Duke Energy Ohio
Case No. 19-1471-EL-BLN
Staff Third Set of Data Requests
Date Received: April 2, 2020
STAFF-DR-03-002

Duke Energy Ohio
Case No. 19-1471-EL-BLN
Staff sECOND Set of Data Requests
Date Received: October 25, 2019
STAFF-DR-02-001

INDEX: F684			
	DESCRIPTION: CONSTRUCTION DRAWING			
DATE: 7/24/2019		LOCATION: HAMILTON CO, OH		
DRAWN: JAKE DAWN			ENGINEER: JAKE DAWN	
TRANSMISSION LINE ENGINEERING	CKD:	PAGE:	SCALE: NOTED	DWG NO: 28935640-1

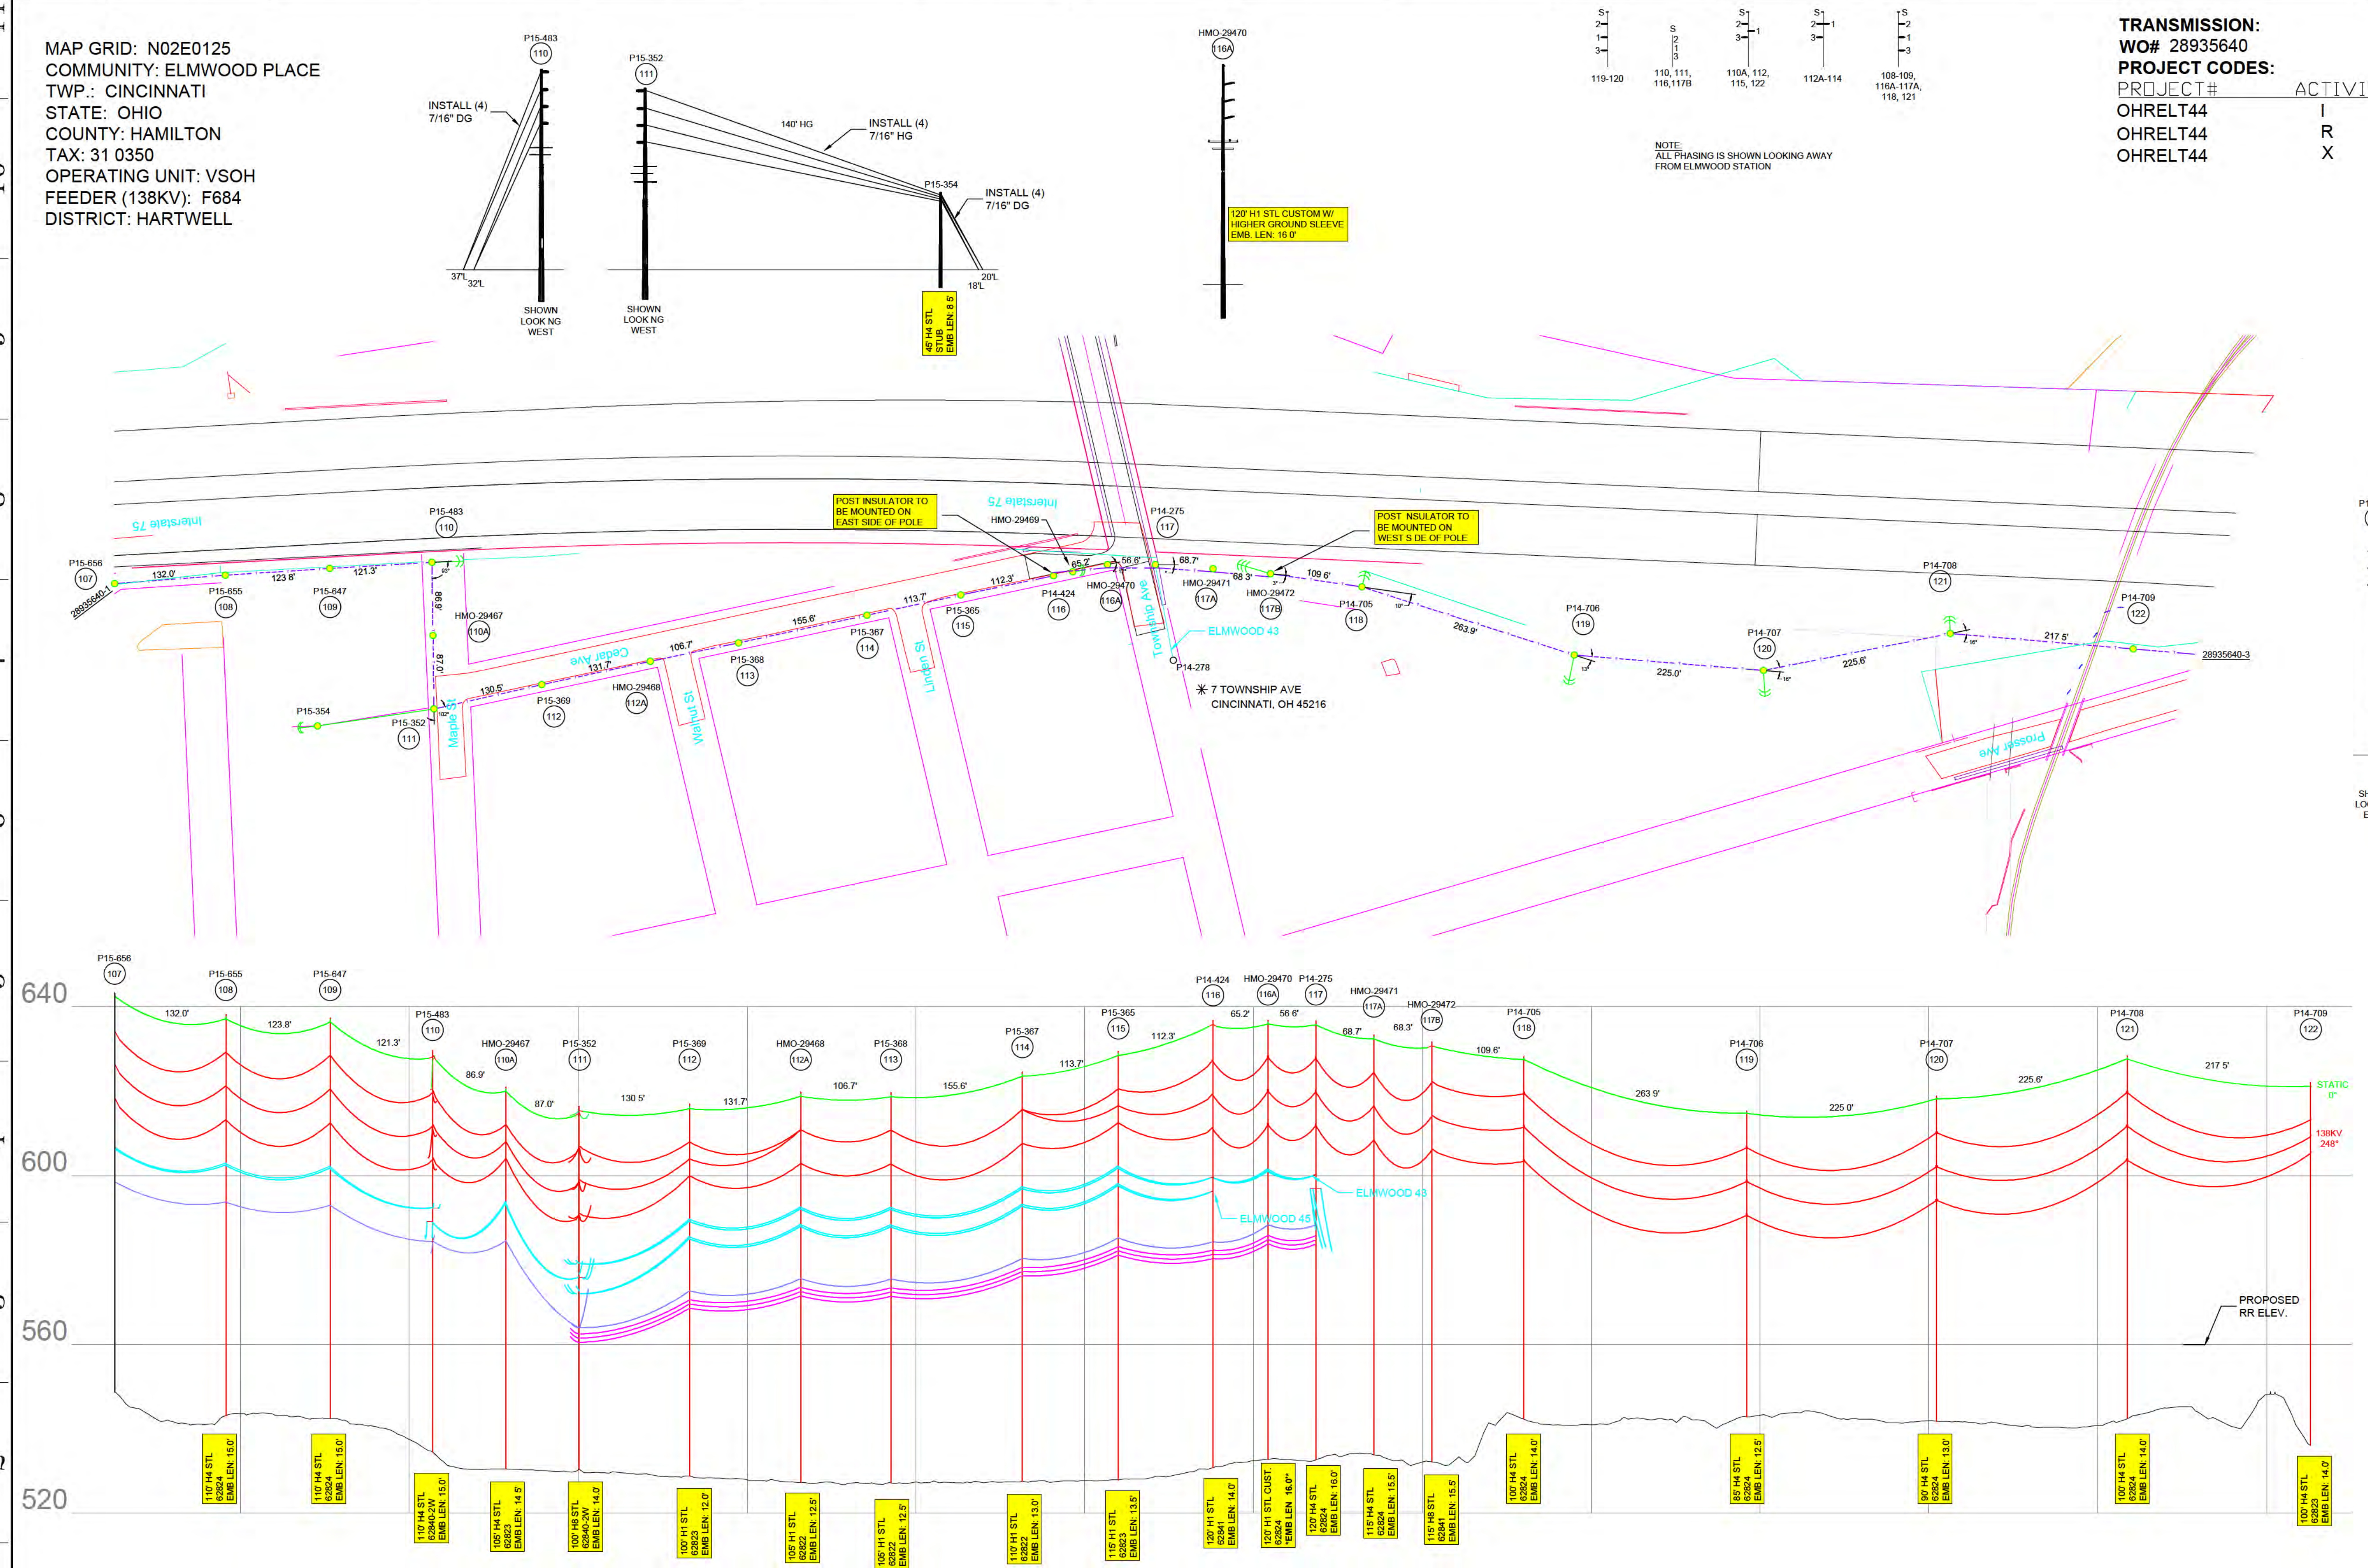
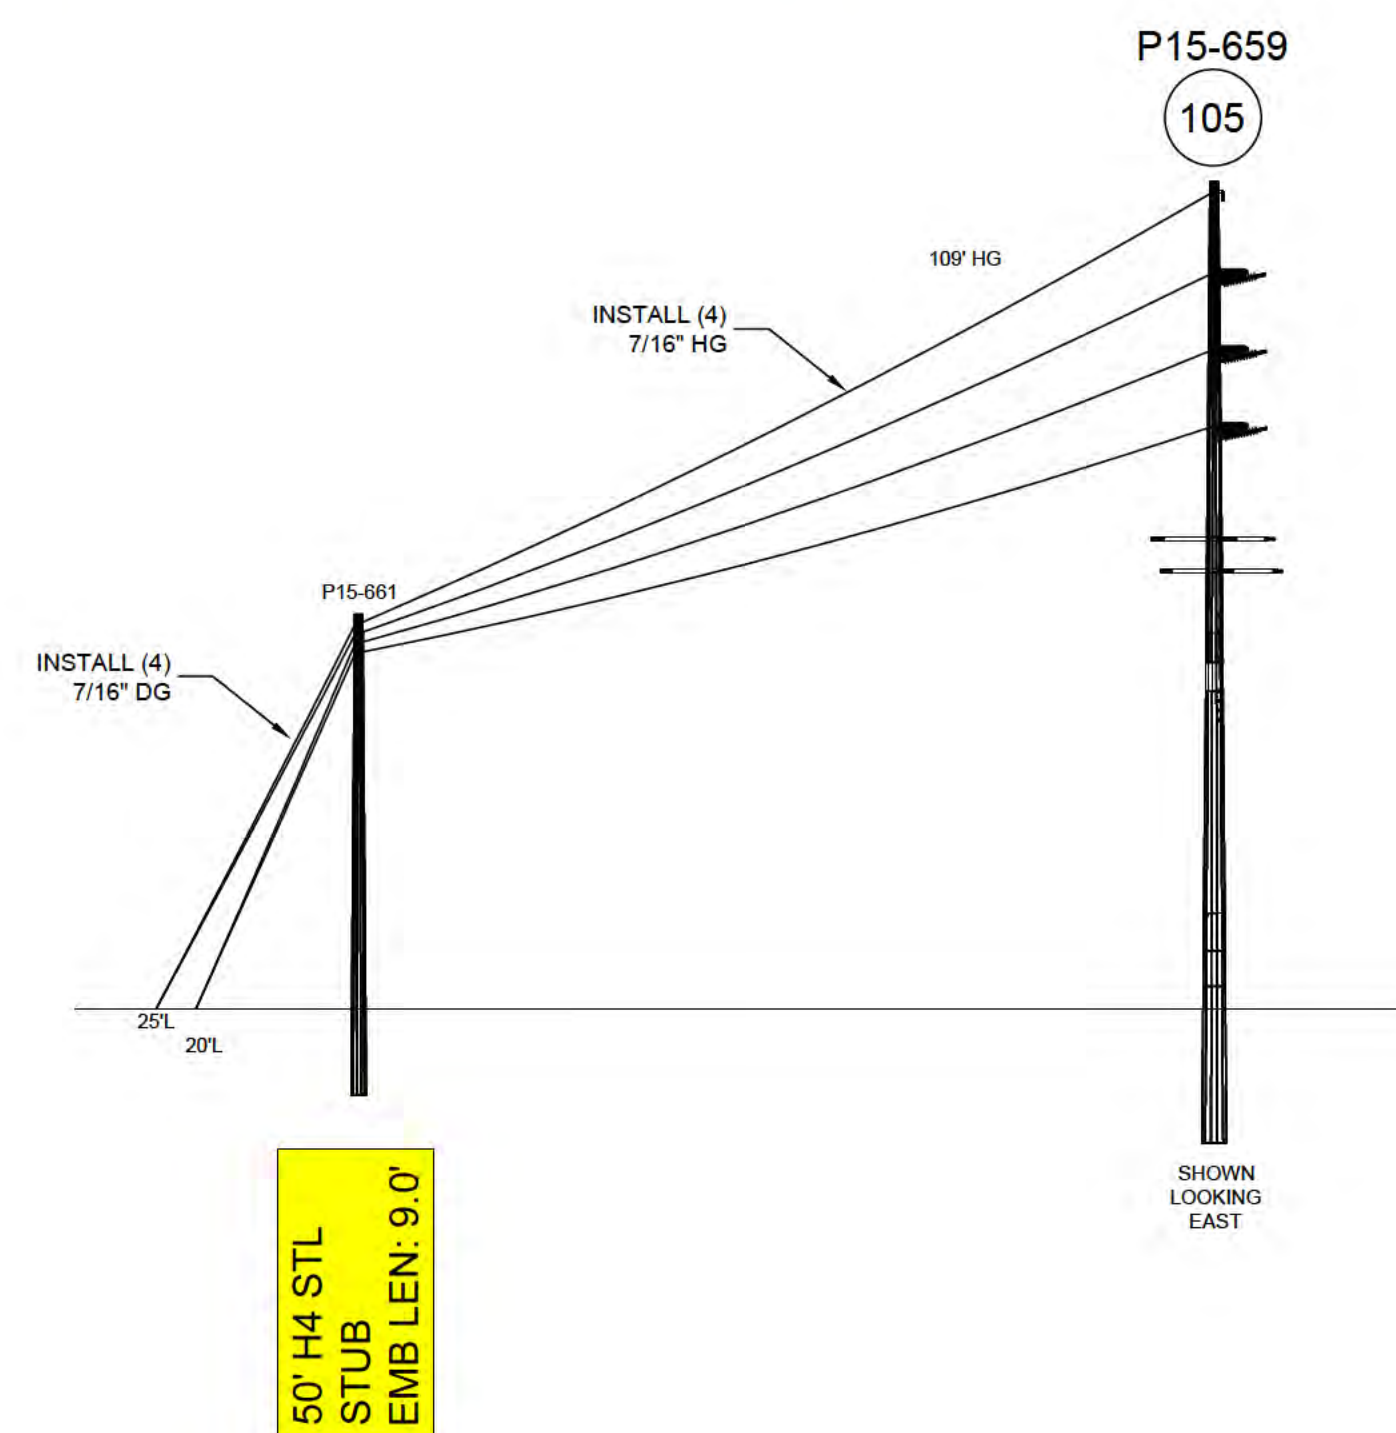
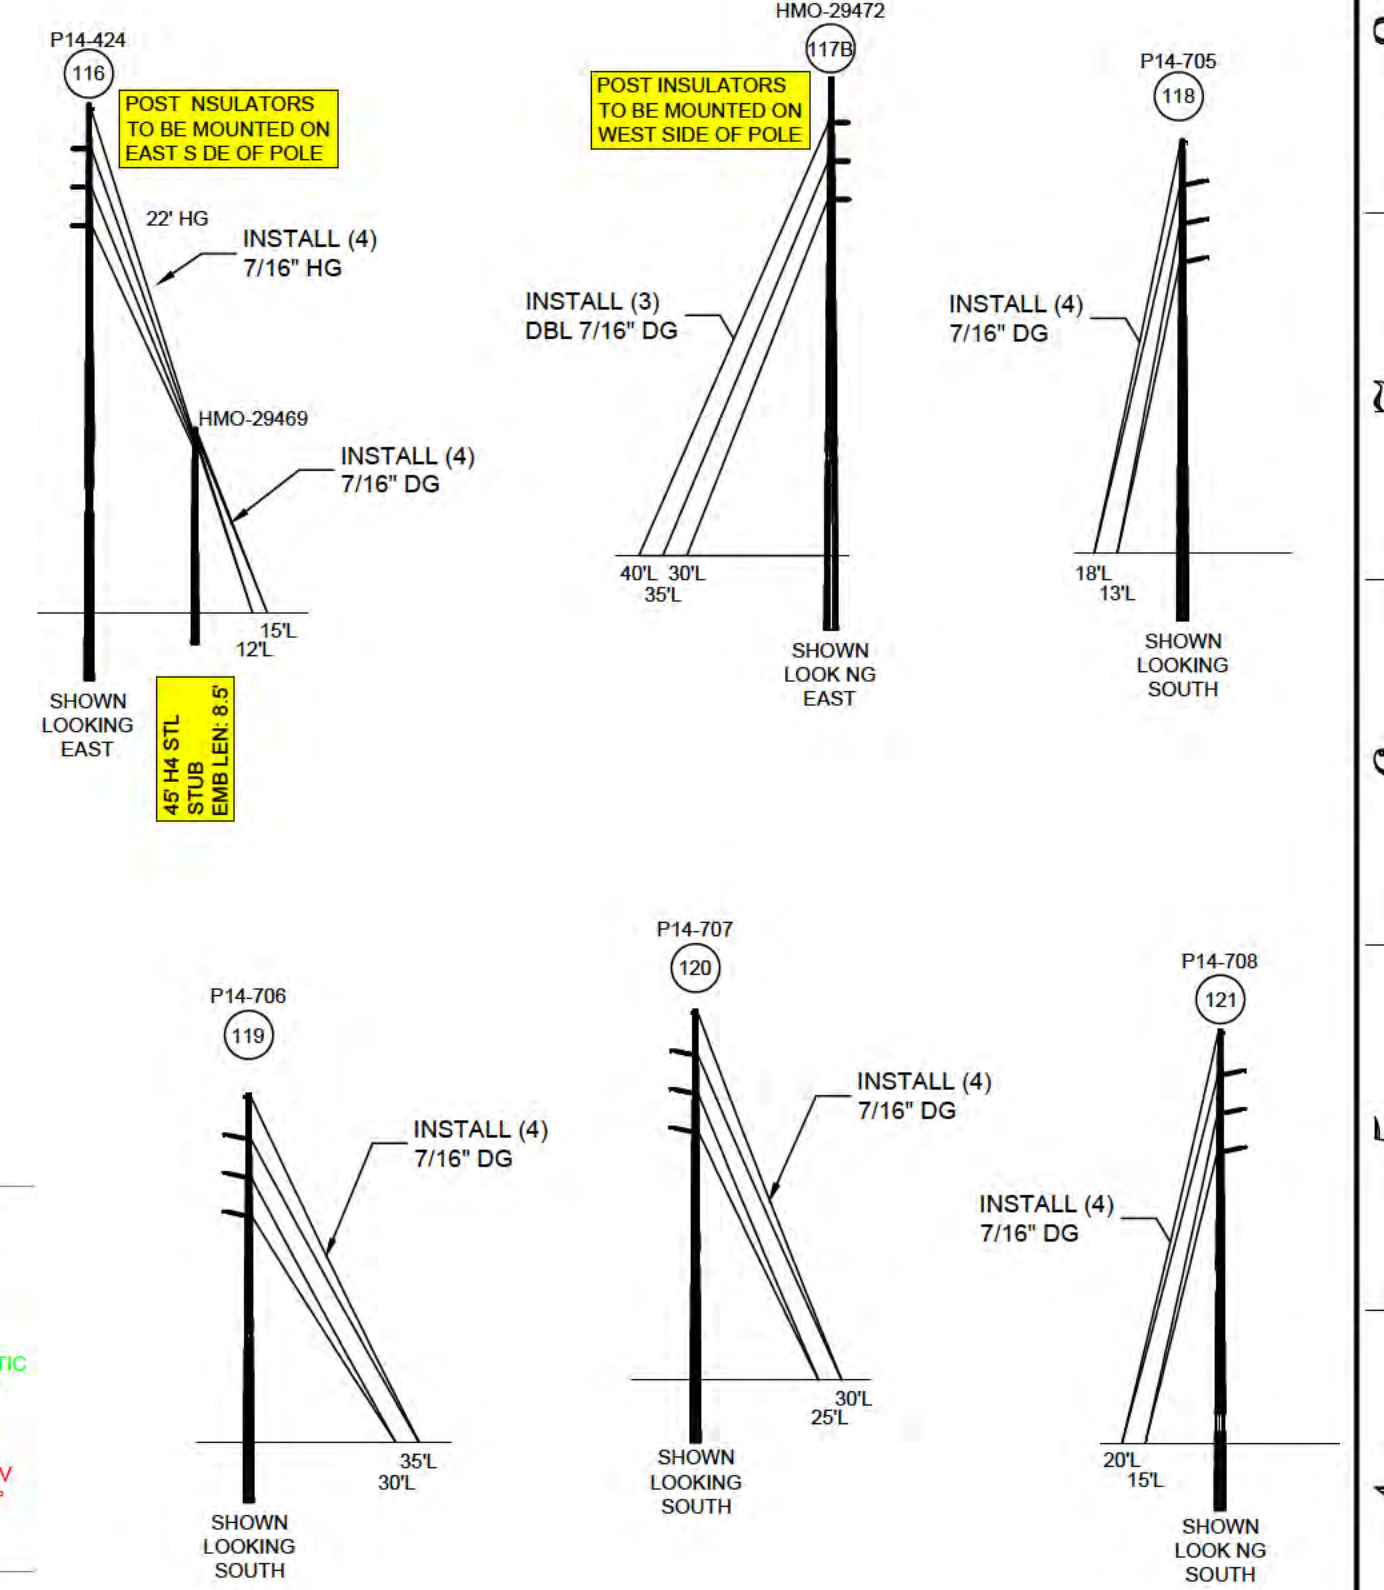
Please explain why the locations of the stub poles were not included in the original maps and shapefiles.

- a. Why are these structures necessary to construct the replacement line?

Please clarify the height of the new structures? The application states the heights of new structures ranges from 73 to 106 feet (46 total). Can you clarify this please, showing which height structures would be used in which locations?

Duke Energy Ohio did include the stub poles in its construction drawings. Please see STAFF-DR-02-001, including Attachments 1-4. This data request response was provided to Staff on October 29, 2019. A copy of that response is also being provided herewith, as Staff-DR-03-002 Attachment 1.

The Company has reviewed the comments and concerns about the stub poles being installed on the Elmwood Project. It has been determined that the stub pole locations were not shown in the maps that were part of the application, although they were shown in the Construction Drawings provided in STAFF-DR-02-001. Duke Energy Ohio's permitting team and engineers has determined that there was a loss of detail in the current method of extracting CAD files into the GIS environment in which the figures are developed. In future exhibits, the Company will extract CAD files using a different method into the GIS environment, in order to fully show the location of the structures (poles, stub poles, etc.).

- a. These structures are necessary to construct the replacement line because they support the guy wires.

Engineering drawings have been attached to show structure height.
